AGENDA ITEM SUMMARY / STAFF REPORT
FLORENCE PLANNING COMMISSION

ITEM TITLE: PC 23 30 DR 06 – *Twombly Hwy 101 Warehouses Design Review*

RESOLUTION PC 23 30 DR 06

**FINDINGS OF FACT
FLORENCE PLANNING COMMISSION
Exhibit "A" Draft**

EXHIBIT G

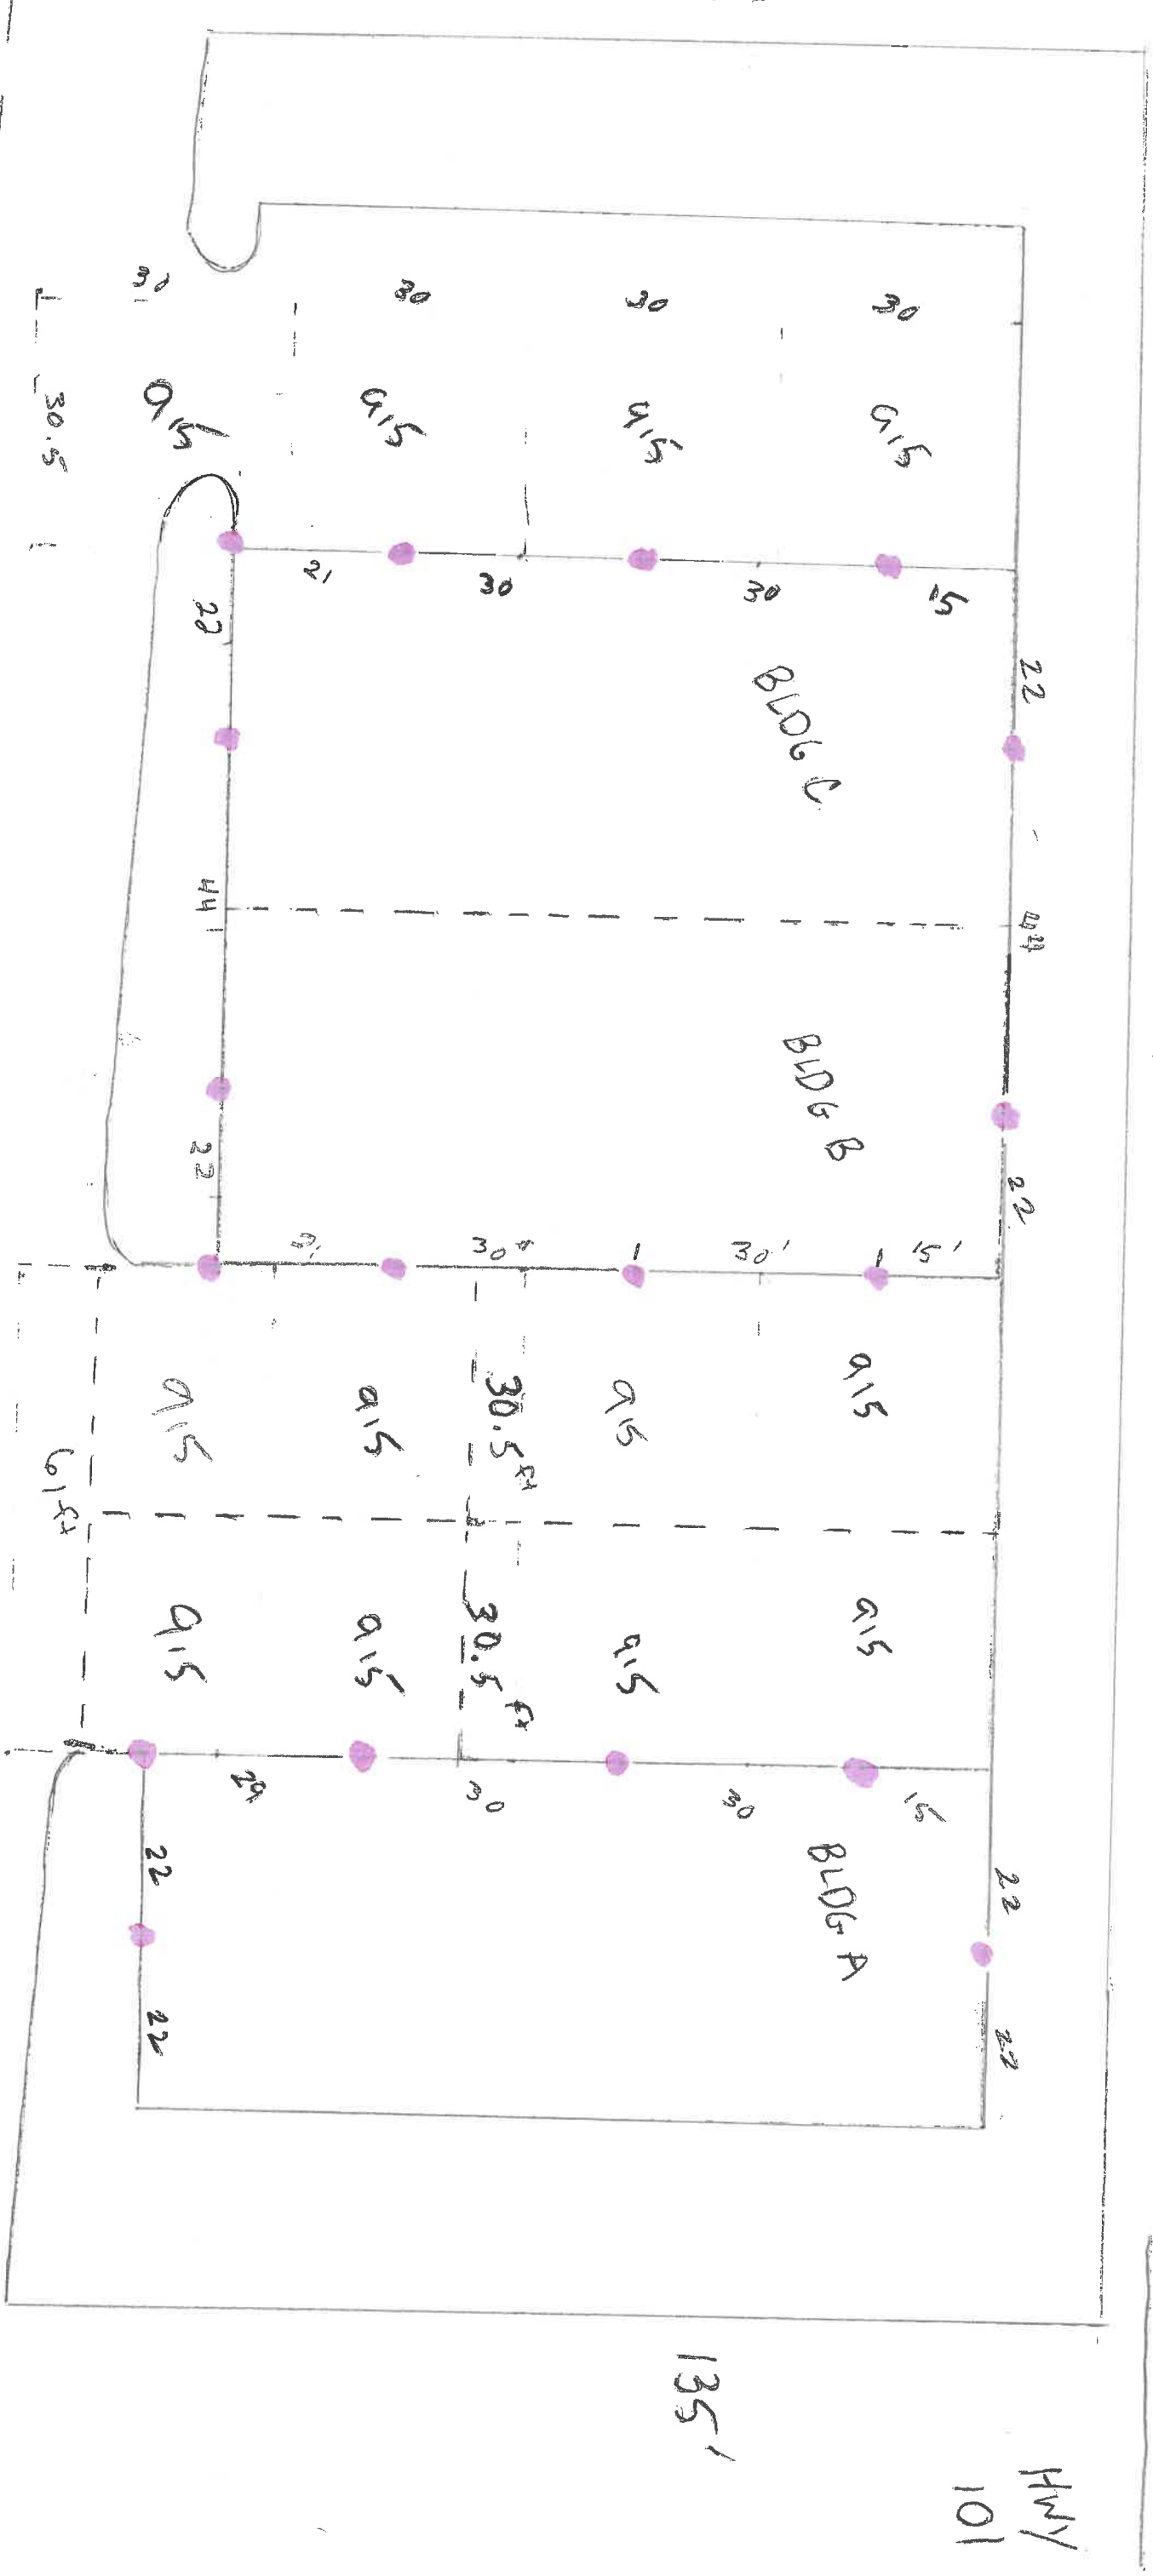
The photometric plan (Exhibit G) explains that all parking areas will be lit using Ring floodlights containing 2000 lumens and that the lumen output would be 2.186 which would not exceed the maximum allowed foot-candles. Ring floodlights are typically motion activated. An example (not provided by the applicant) of this lighting is shown in the image, below, and appears to be adjustable to ensure full cut-off and is able to be monitored remotely:

- 10-1. Prior to, or in conjunction with submittal of building plans this information shall be submitted to the City Planning Department for review, which shall include full-cut off light fixtures in compliance with the code section above, and may be processed as a Type I Administrative Review.
